CORRESPONDENCE CONCERNING RCRA FACILITY INVESTIGATION REPORT  
ADDENDUM FOR SOLID WASTE MANAGEMENT UNITS 136 AND 138 AND 196 AND 17  
(SWMU 136 AND 138 AND 196 AND 17) AND AREAS OF CONCERN 663 AND 666 AND 667  
(AOC 663 AND 666 AND 667) CNC CHARLESTON SC

Re: RCRA Facility Investigation (RFI) Report Addendum for SWMUs 136, 138, 196, & 17 and AOCs 663, 666, and 667 located in Zone H of the Charleston Naval Complex, SCO 170 022 560, Revision 0, dated May 5, 2000, received May 19, 2000.

Zone H RFI Addendum Report,  
SWMUs/AOCs 136, 663, 666, 138, 667, 196, 17  
Dated May 5, 2000

**Zone H RFI Report Addendum,  
Charleston Naval Complex (CNC)  
Michael W. Danielsen**

Figure 1  
Zone K Proposed Offsite DPT Locations

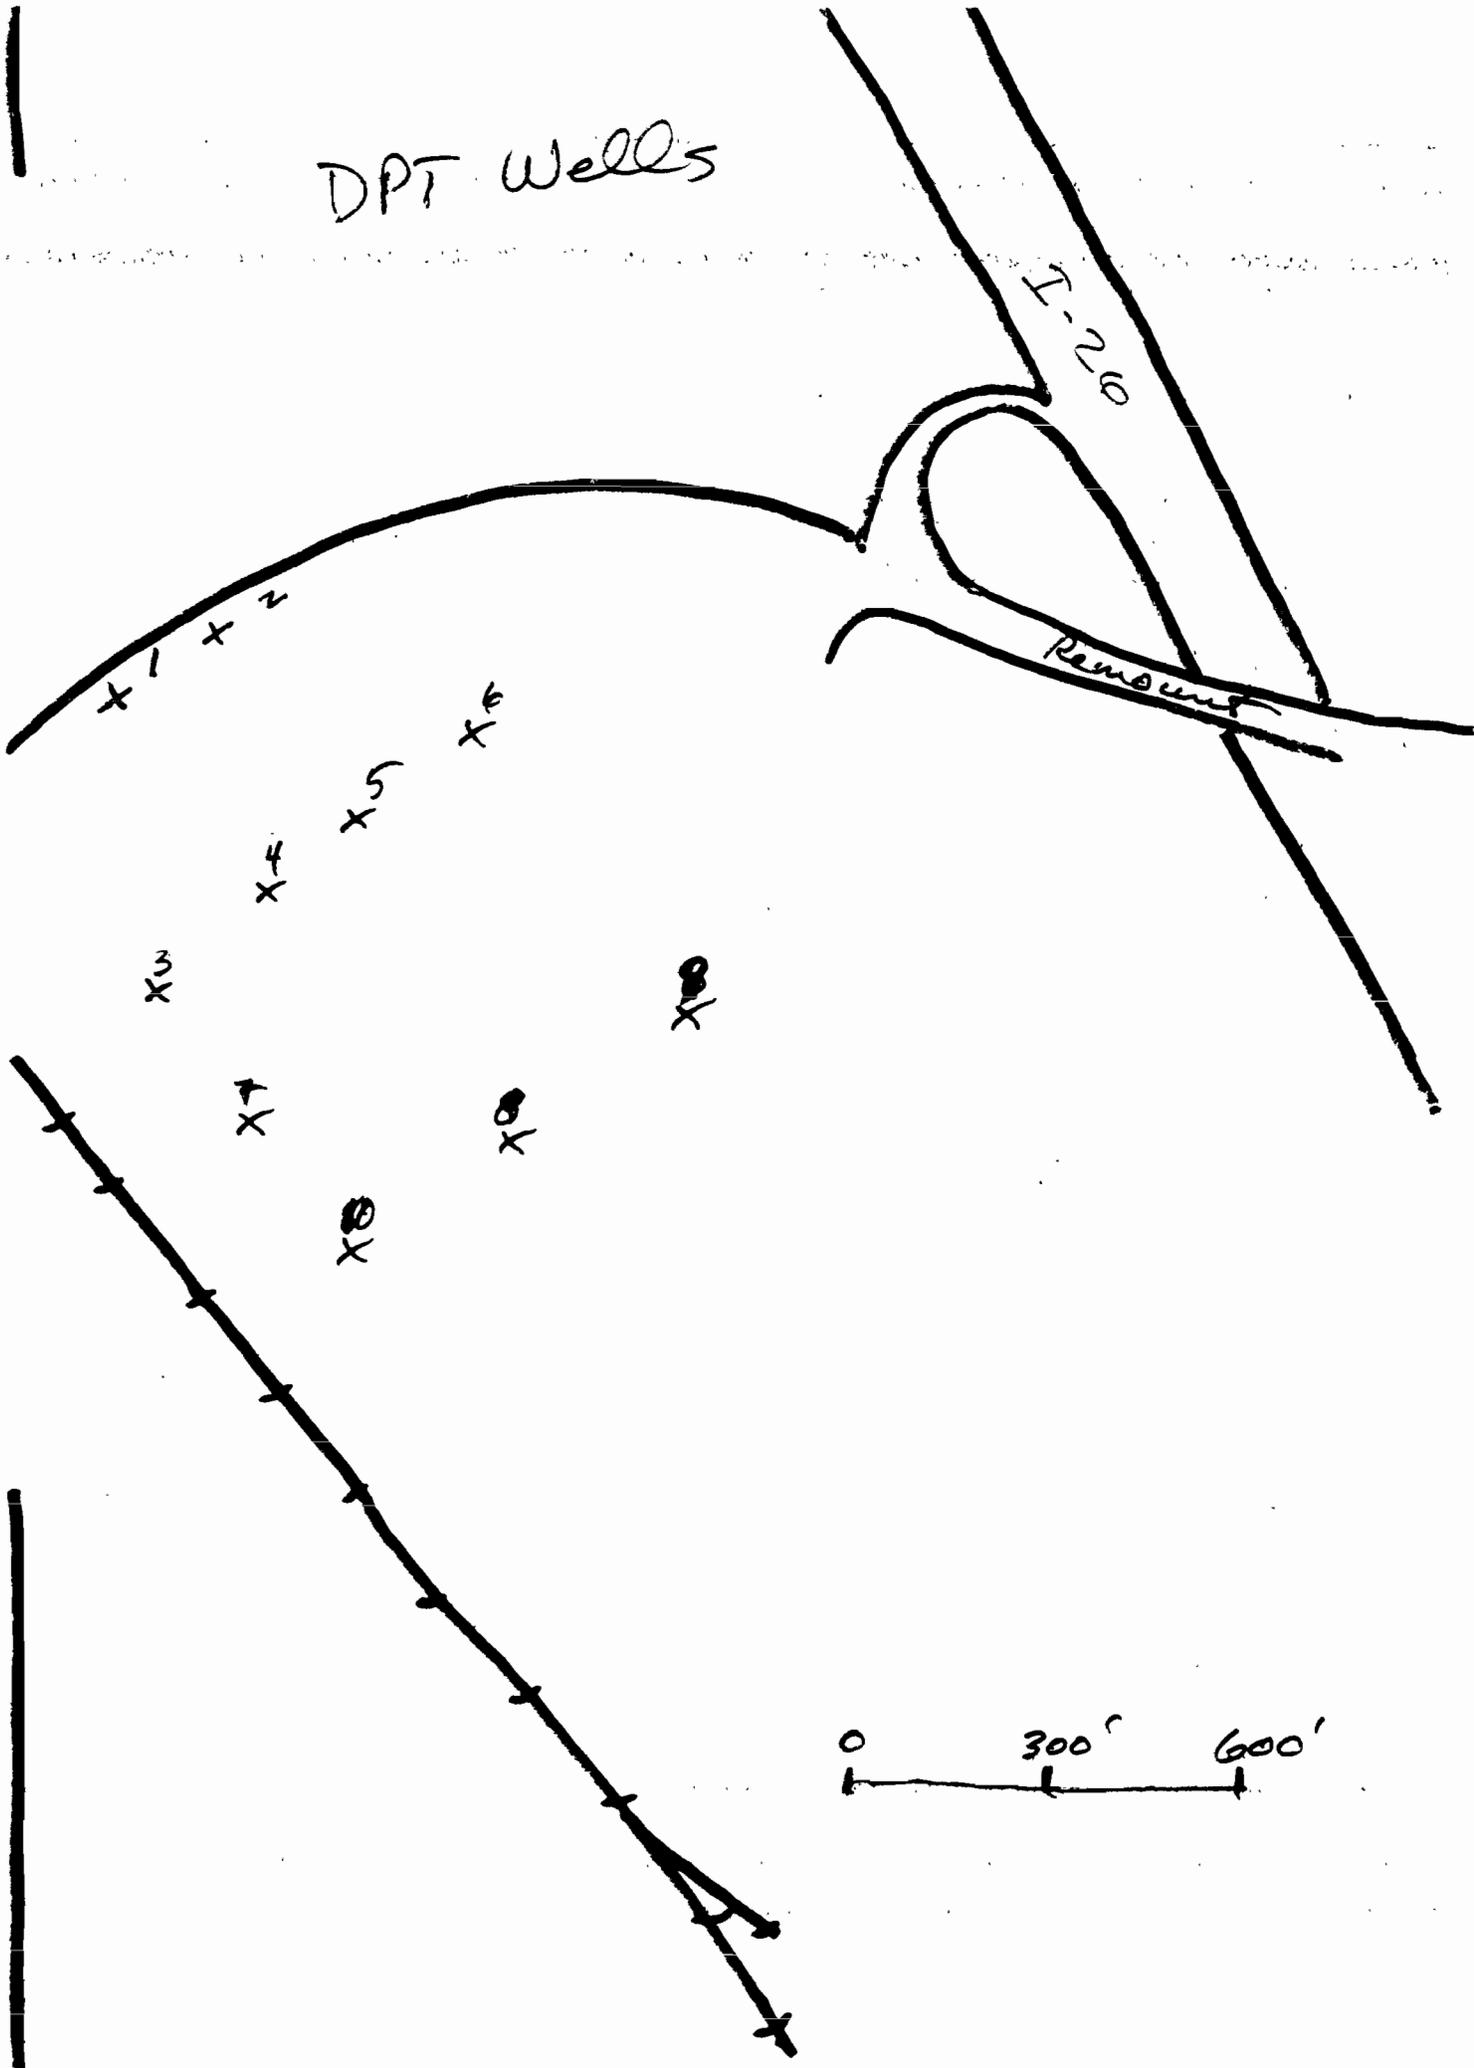
Attached, please find a copy of the proposed well locations. A copy of the well approval form and this letter should be on site during drilling operations. Additional assessment may be required at these well locations. Should there be any questions, please contact me at (803) 896-4016.
